CITY OF OAKLAND

Memorandum

Re: DRC Review Fruitvale Transit Village Phase II

Design Review Committee Staff Report

WEST ELEVATION - TRANSPARENCY

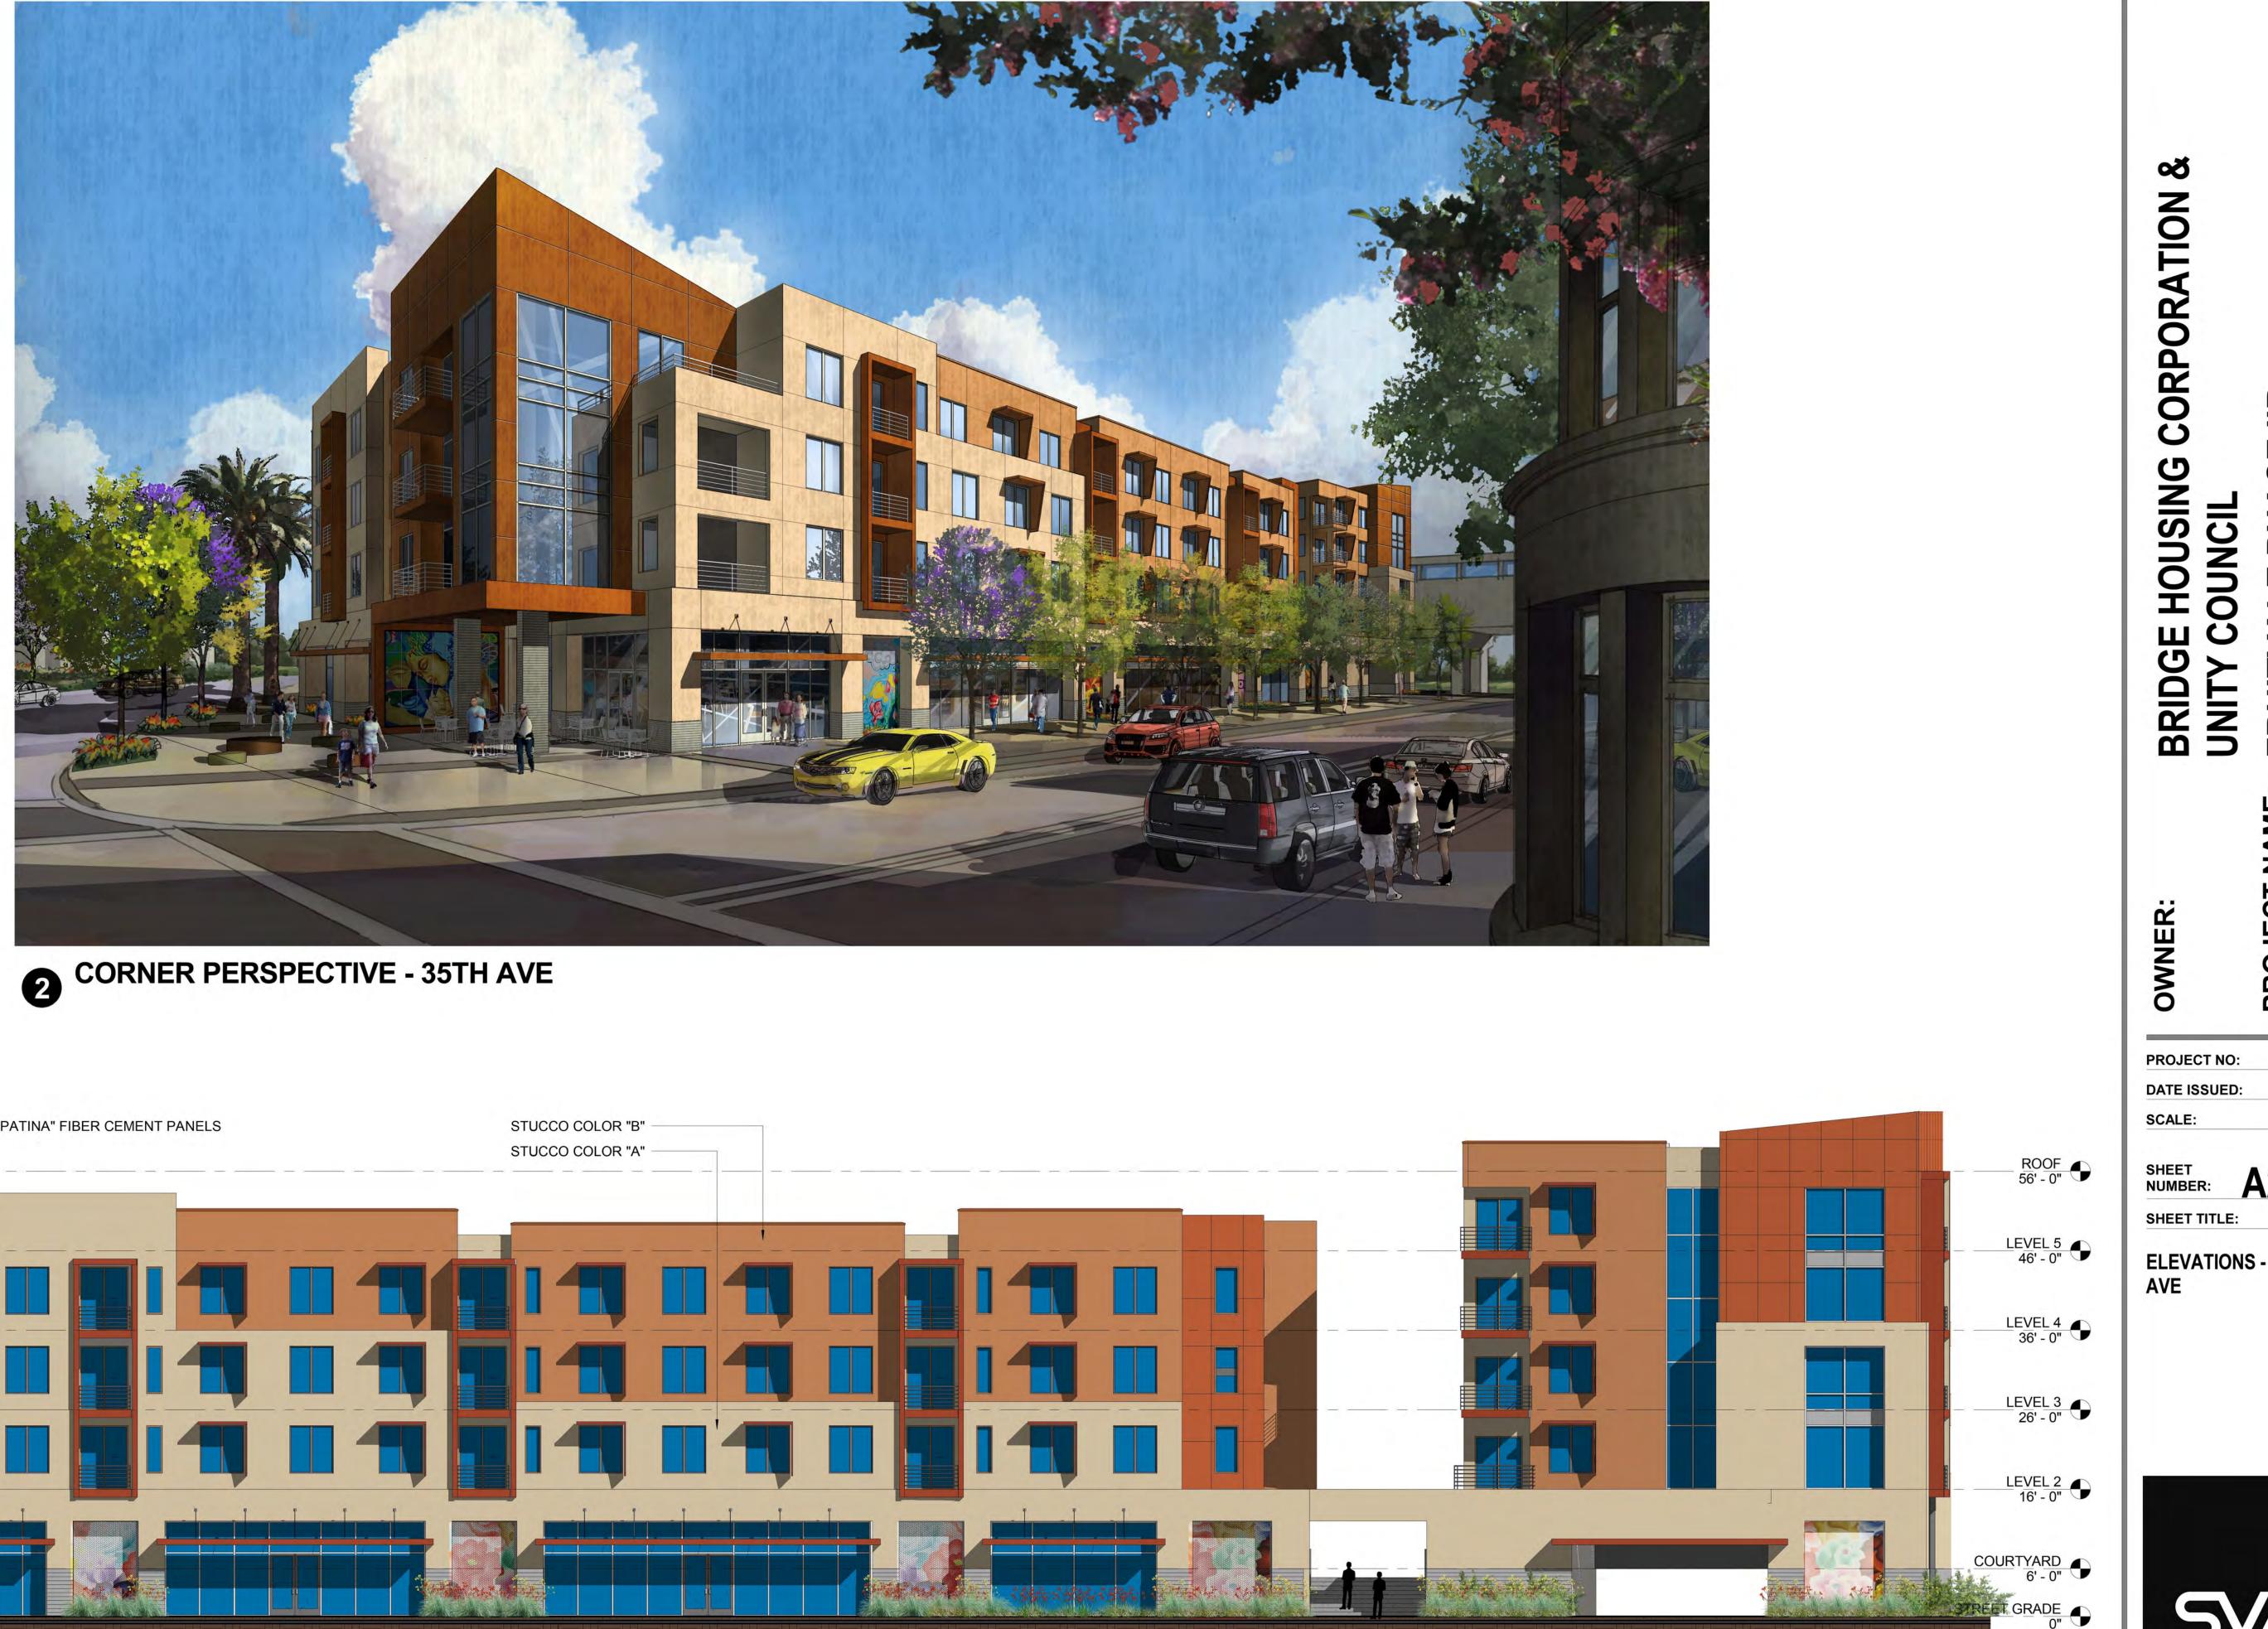
Page A21 West Elevation 35th Ave

- On this elevation, board-form concrete material is added to the base replacing tan stucco on the first floor. This new material extends to the top of the windows and mural display. This change creates a significantly stronger base statement and enhances the mural display areas.
- Variation is provided using color changes to break up the massing of the building.
- Three types of window treatment are proposed showing and the effect of a window frame is created by recessing the window on the base stucco color 1 (Tan) portion of the building.

NORTH ELEVATION - EAST 12TH ST 1" = 10'-0"

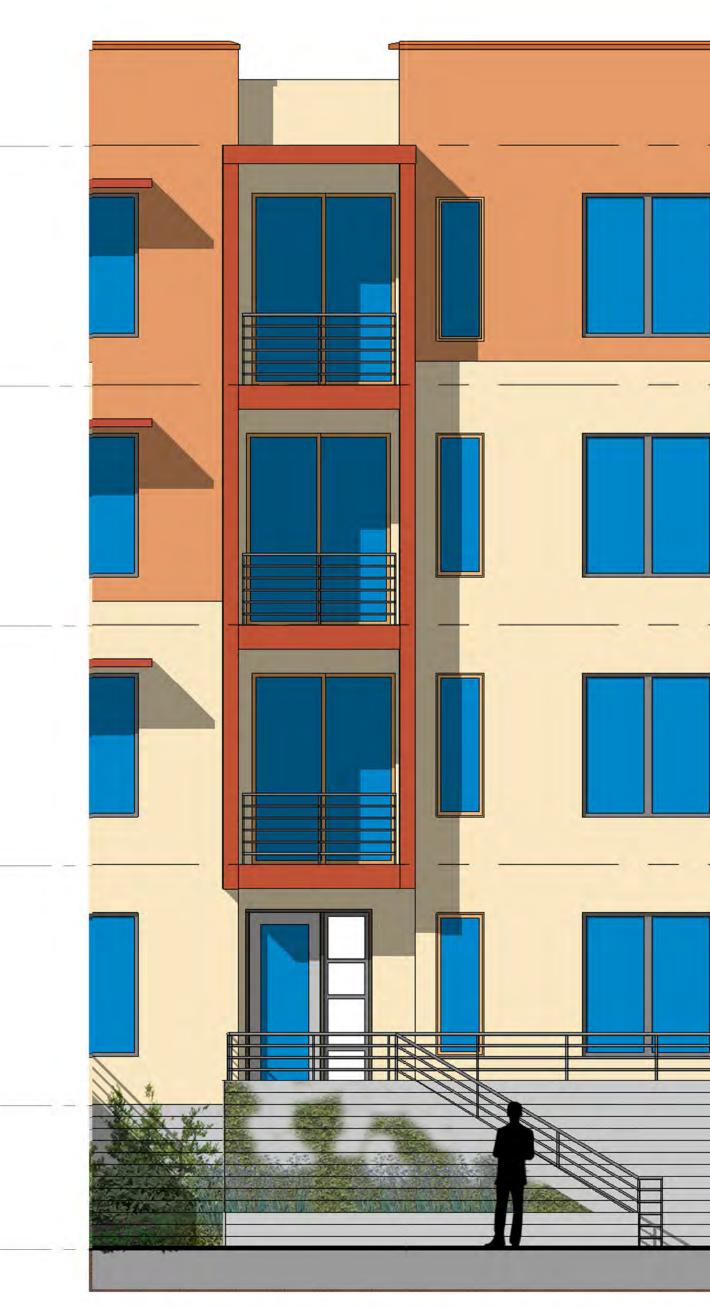
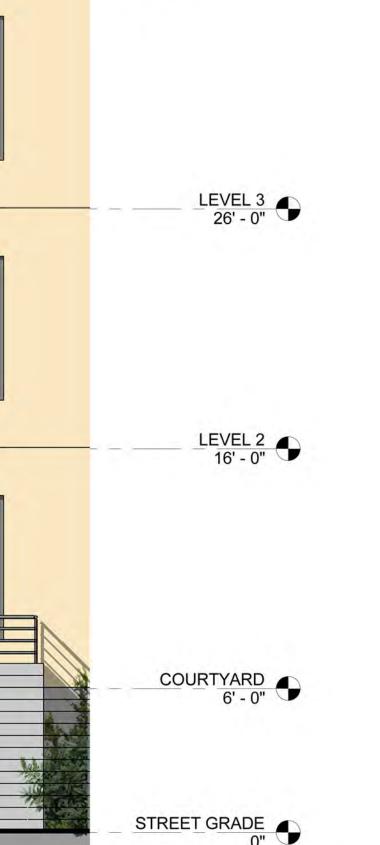
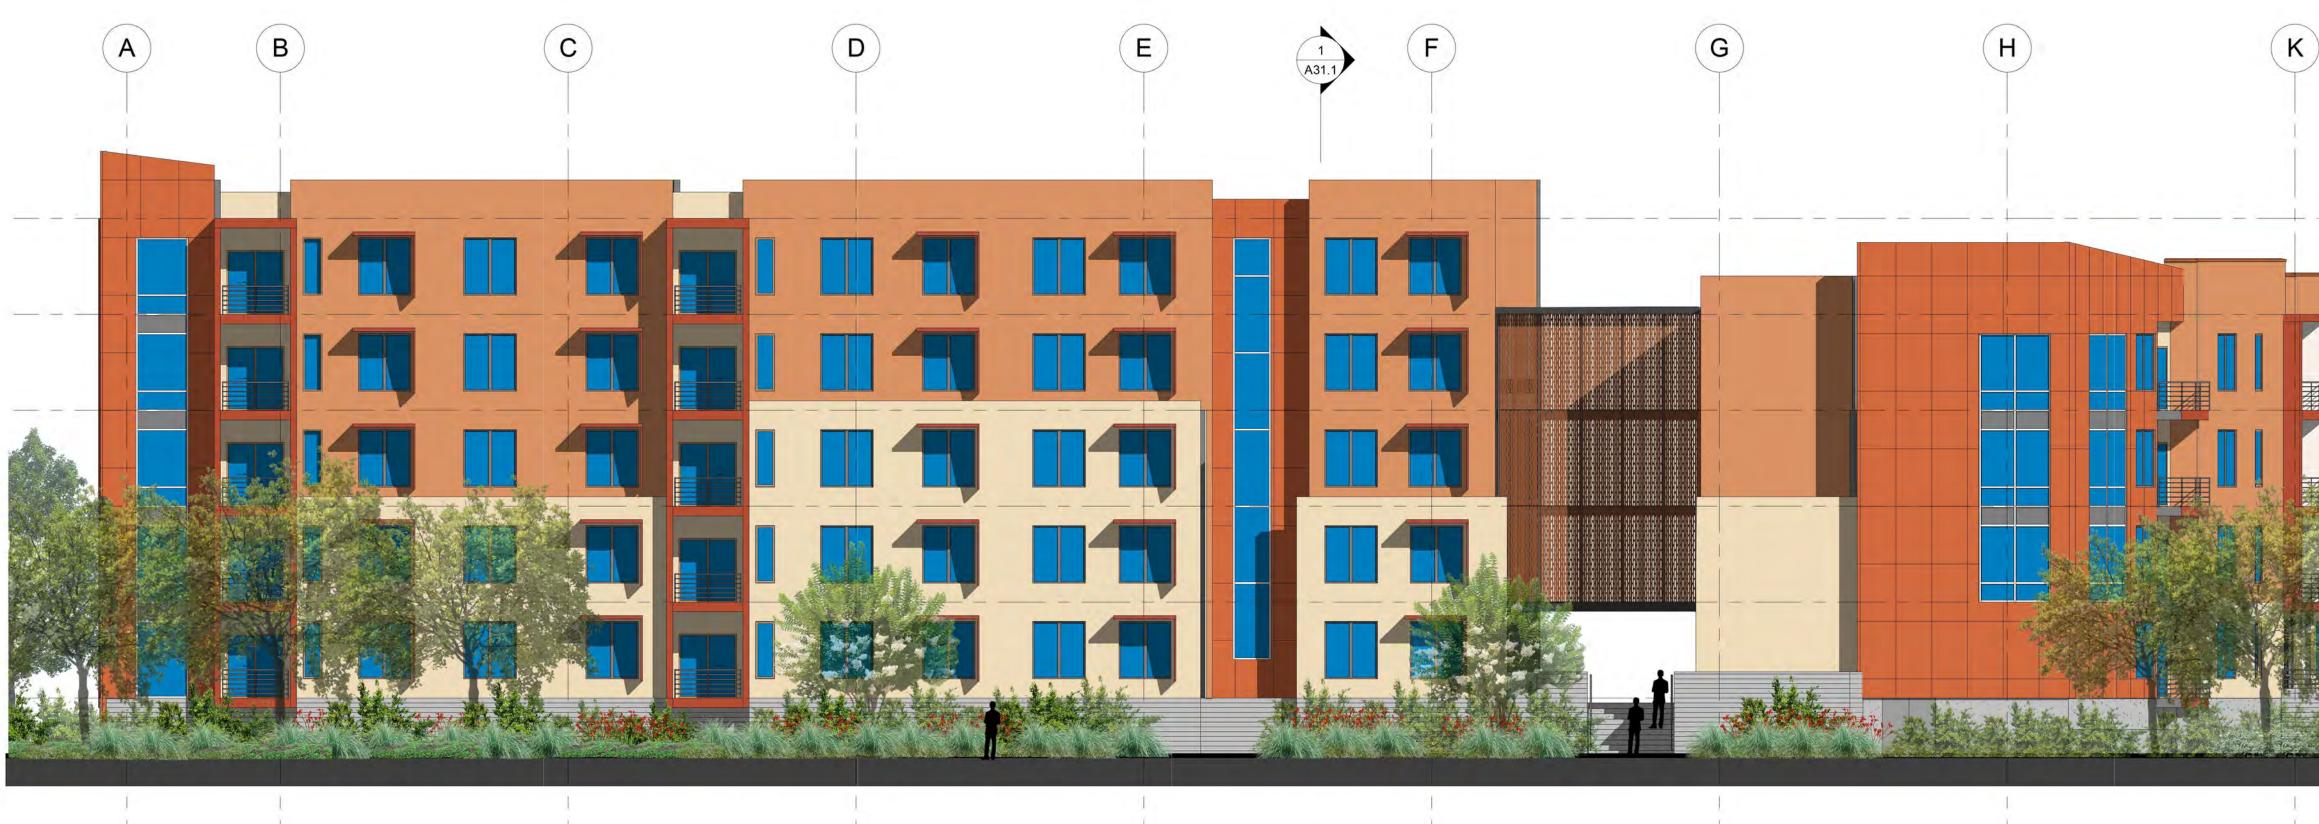
Page A24 North Elevation E 12th Street

- Fiber cement lap siding and a roof top element are added on the residential-only part of the building. This change differentiates the materials and, as a result, the building reads more like a series of adjacent elements.
 - Reconfiguration of the color pattern also creates more variation in the façade.
 - 1. Stucco color 2 (upper) is extended to the base of the building between the stoops
 - 2. Stucco color 1 is applied to fiber cement lap siding on the first 3 stories on part of the building.
 - 3. Stucco color 1 is retained on the portion of the building over the nonresidential space creating greater variation.
- Variation in window treatment is provided with three window types.
